DFFE Reference: 14/12/16/3/3/1/2385/AM1

CORRECTION IN TERMS OF REGULATION 27 (4) OF THE ENVIRONMENTAL IMPACT ASSESSMENT (EIA) REGULATIONS, 2014, AS AMENDED TO THE ENVIRONMENTAL AUTHORISATION ISSUED ON 31 JANUARY 2024 FOR THE IGOLIDE WIND ENERGY FACILITY (UP TO 100 MW) NORTHEAST OF FOCHVILLE, WITHIN THE MERAUFONG CITY LOCAL MUNICIPALITY, WEST RAND DISTRICT MUNICIPALITY IN THE GAUTENG PROVINCE.

In terms of Regulation 27 (4) of the Environmental Impact Assessment (EIA) Regulations, 2014, as amended this Department has decided to amend the abovementioned decision to correct a typographical error to include cabling, final layout plan, and correct Heritage recommendations as follows:

Figure 11-1 –Final Layout for Approval/Authorisation

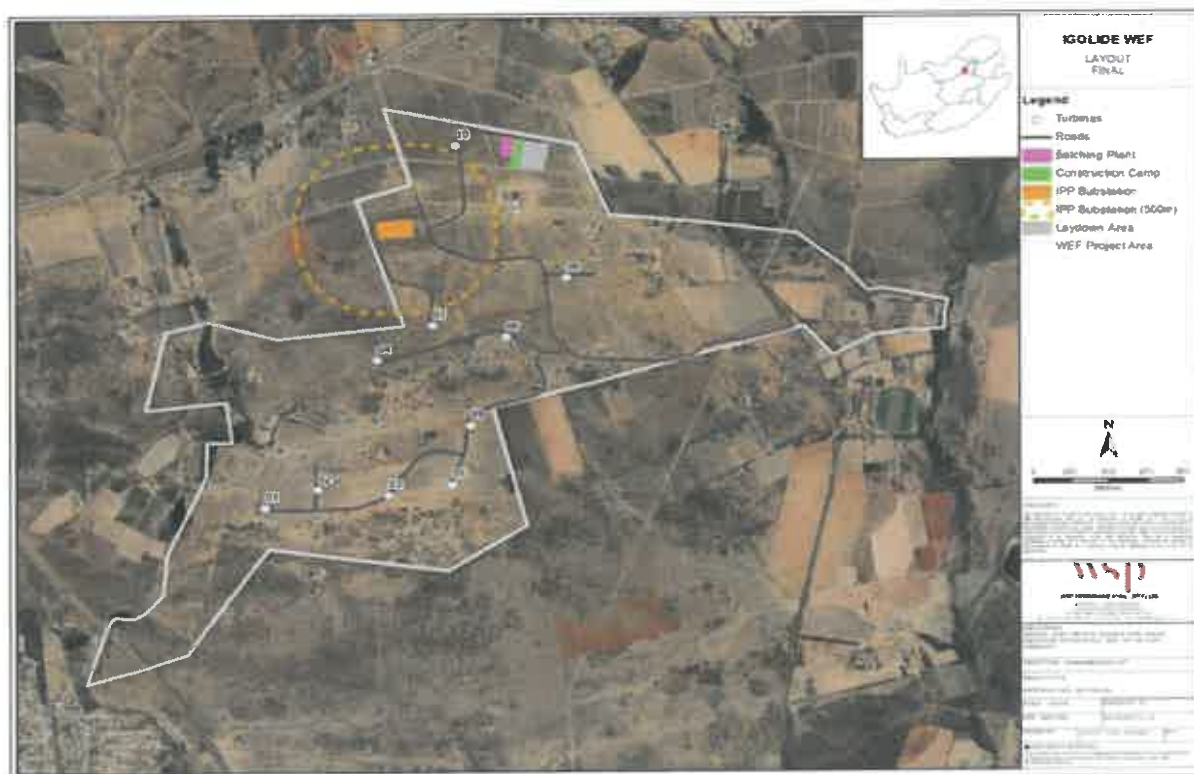
Correction 2 – Incorrect Layout in Annexure 2 of the EA

The layout included in Annexure 2 of the EA is the scoping phase layout and not the Final EIA layout put forward for authorisation.

The layout in Annexure 2 is updated to reflect the correct Final Layout as illustrated in Figure 11-1 on page 389 of the Final EIR.
